SS 1033315 - WST 5700 Exhaust Pipe Installation Bracket Improvements

WST 5700

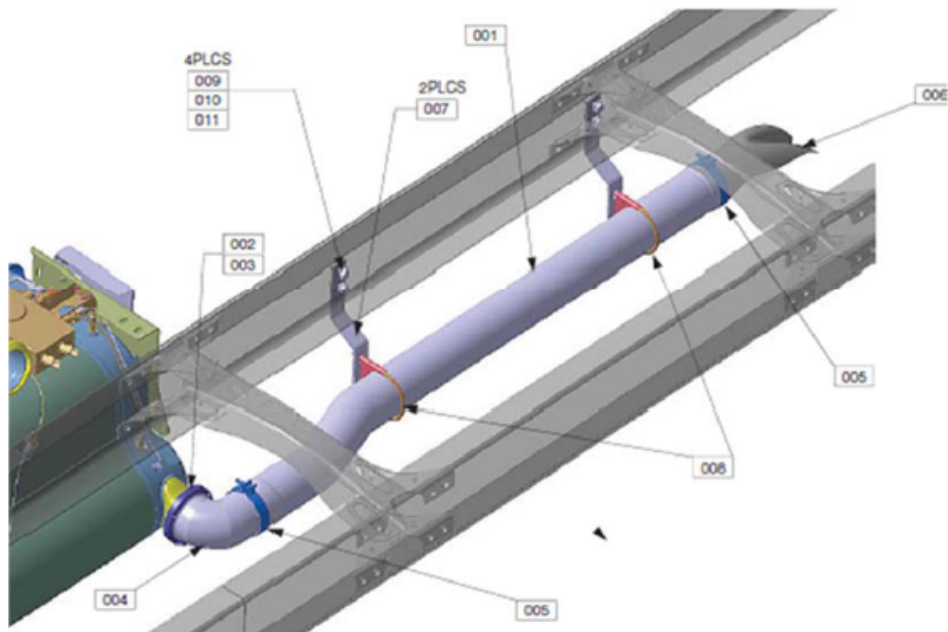
Early and repetitive failures of the Exhaust Pipe Installation Brackets.

More robust design of Exhaust Pipe Bracket is available for current application.

A new Exhaust Pipe Bracket is available and can replace the current production bracket with minor additions as described below:

001 – INSTL. EXHAUST, 016-1C3, 2 BRKT, DD15/3

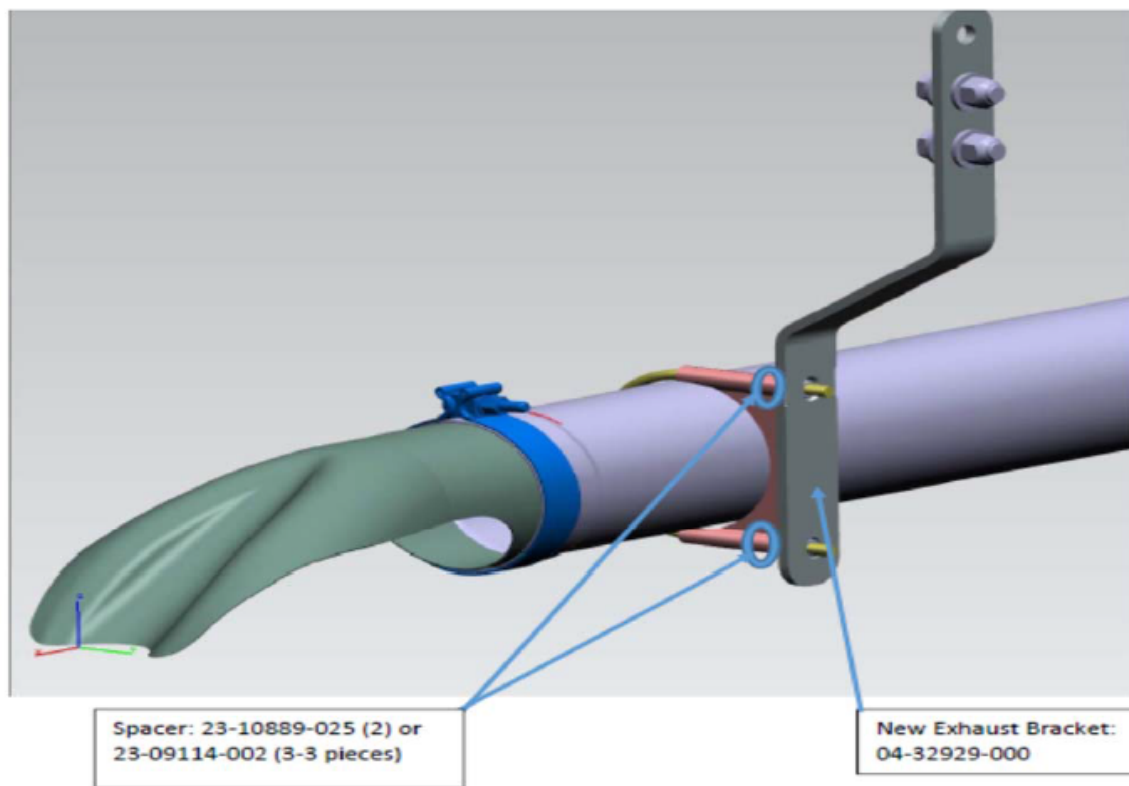
Current installation shows items 7, 04-31835-00 (2Plcs) that need to be updated with new bracket 04-32929-000:

Remove 04-31835-000 and mounting bolts/nuts and install 04-32929-000 adding spacer: 23-10889-025 (2 pieces per bracket install) or 23-09114-002 (3 pieces per bracket – 6 pieces total) in the clamp side as shown.
